3809
(U-050)
UTU-71640
August 14, 2000

RE: Updated Notice and Inspections of Project Area

On June 14, 2000, the project area for KSC Rocks was inspected by staff of the Bureau of Land Management and the Utah Division of Oil, Gas, and Mining. This project area is in section 23, T. 26 S., R. 4 W., SLM. The case file is serialized as UTU-71640, and the notice is filed for mining activity on mining claim KSC No. 1 (UMC-362224).

Plan View Map

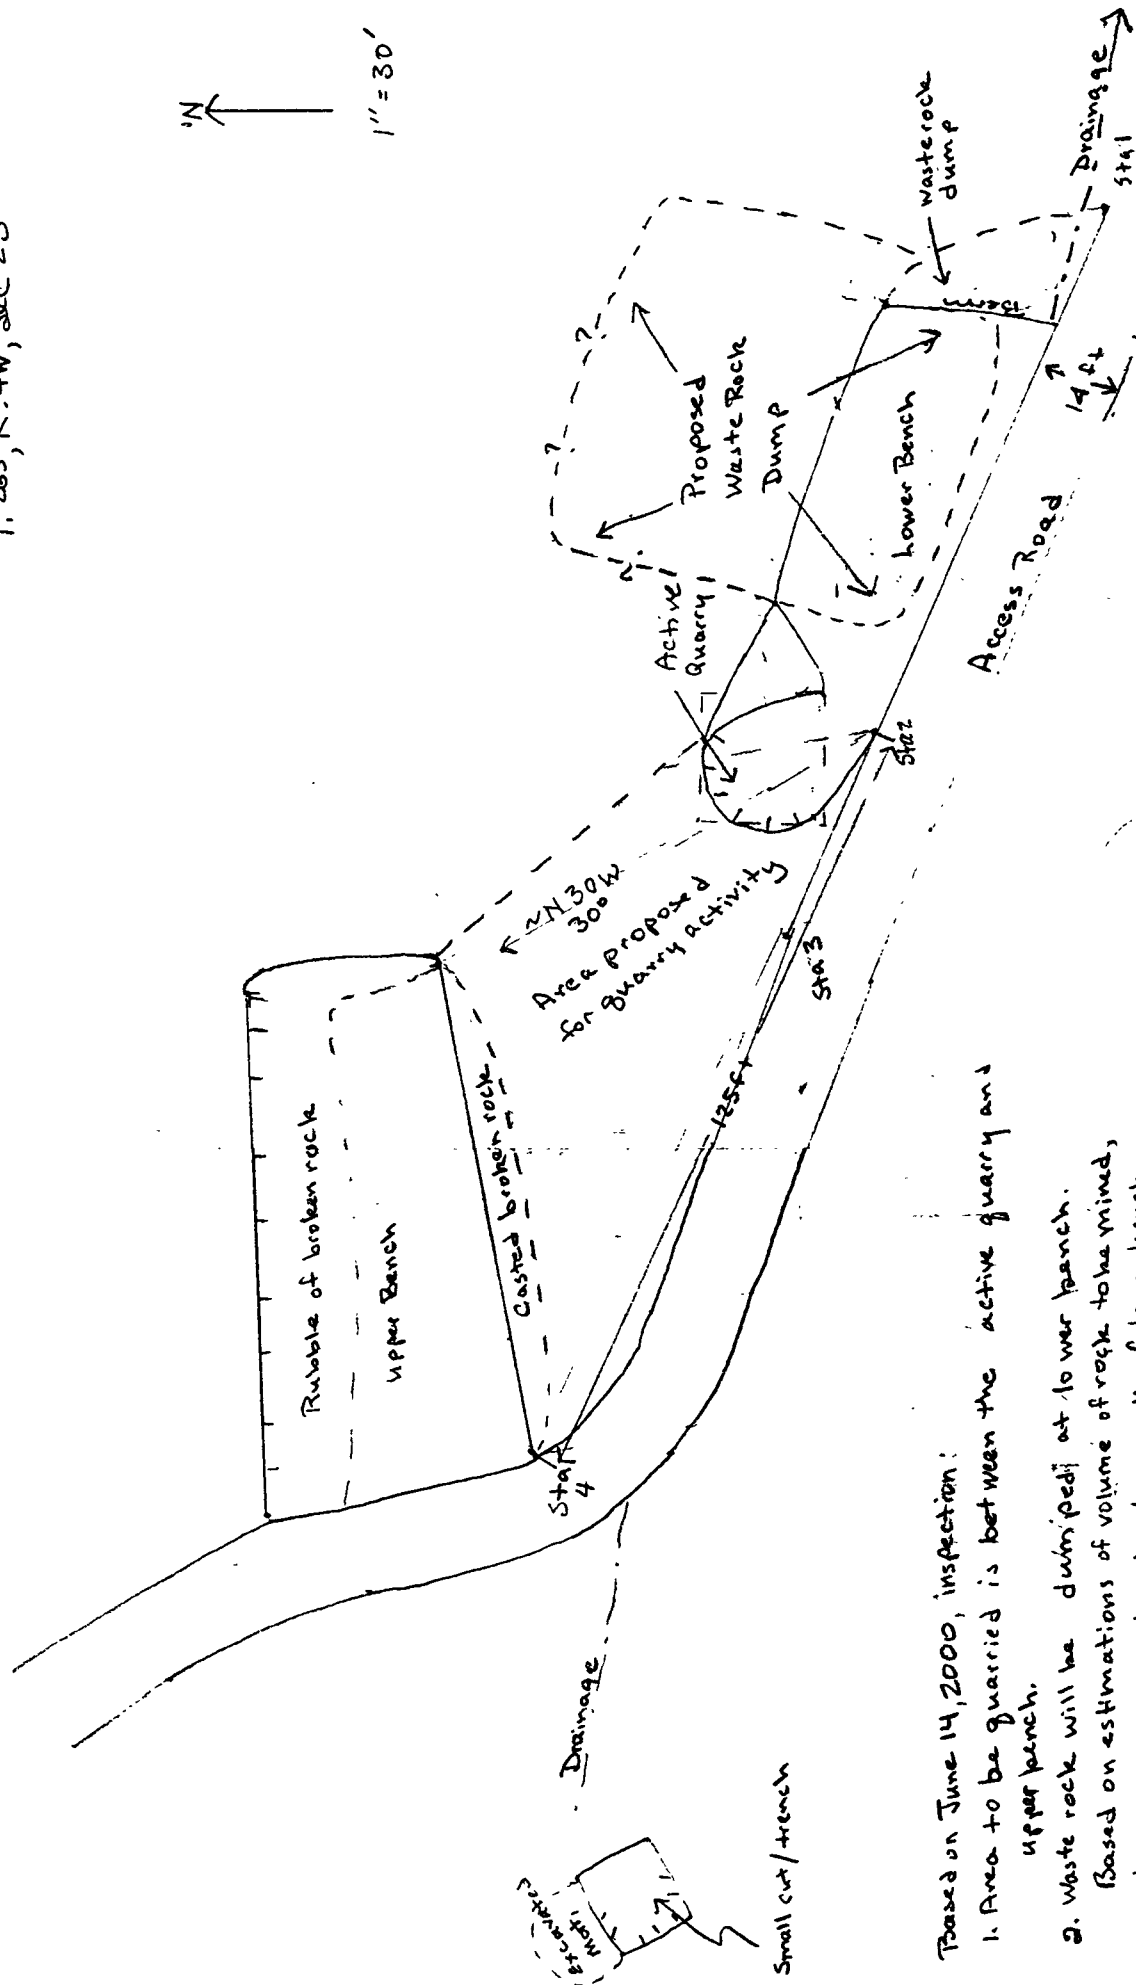
At the quarry at present, the highwall is about 10 feet in height, and the quarry would be extended to an existing, upper bench that is an open cut. (See map.) The elevation difference is about 30 feet, thus, mining would increase the height of the highwall, if the quarry floor is maintained at the present level. Increasing the height of the highwall is a safety concern. Mining in that area could also leave the access road elevated above the quarry floor, which would also be a safety concern. In addition, the waste rock dump, based on rough volume estimates, could exceed 15 feet in vertical height, extend northward of the present lower bench, and impede natural runoff in the ephemeral, stream drainage.

A small trench is shown on the enclosed map, west of the existing quarry, and is assumed to be part of your operations. To our knowledge, that trench was not described in the previous notices. That disturbance is now considered be part of your work.

Based on June 14, 2000, inspection:

1. Area to be quarried is between the active quarry and upper bench.

2. Waste rock will be dumped at lower bench.

Based on estimations of volume of rock to be mined, dump would extend onto slope north of lower bench.

Actual configuration of quarry is not planned by operator at this time.

Highwalls and any other slopes shall be maintained in a manner that will not pose a safety hazard to humans, wildlife or livestock. If your mining activity would create a highwall or waste rock dump that exceeds 10 feet in height, then an amended notice must be submitted to this office, prior to creating that disturbance, to address the measures that you would take to ensure public safety and slope stability.

1. The upper 6 inches of topsoil material at undisturbed areas should be stripped and stockpiled separately from any waste rock material. If this material is stockpiled for more than one year, then the material should be seeded and vegetation established to stabilize the pile. The topsoil stockpile should be placed in a location that will not be susceptible to erosion and an area that will not be disturbed by future mining operations. *Please indicate the location that is proposed for the topsoil stockpile on the enclosed map, and return to this office.*

3. Stockpiles or dumps should not block the drainage that trends through the project area.
4. After mining out a portion of the quarry and to the extent practical, the quarry should be backfilled and recontoured with waste rock.
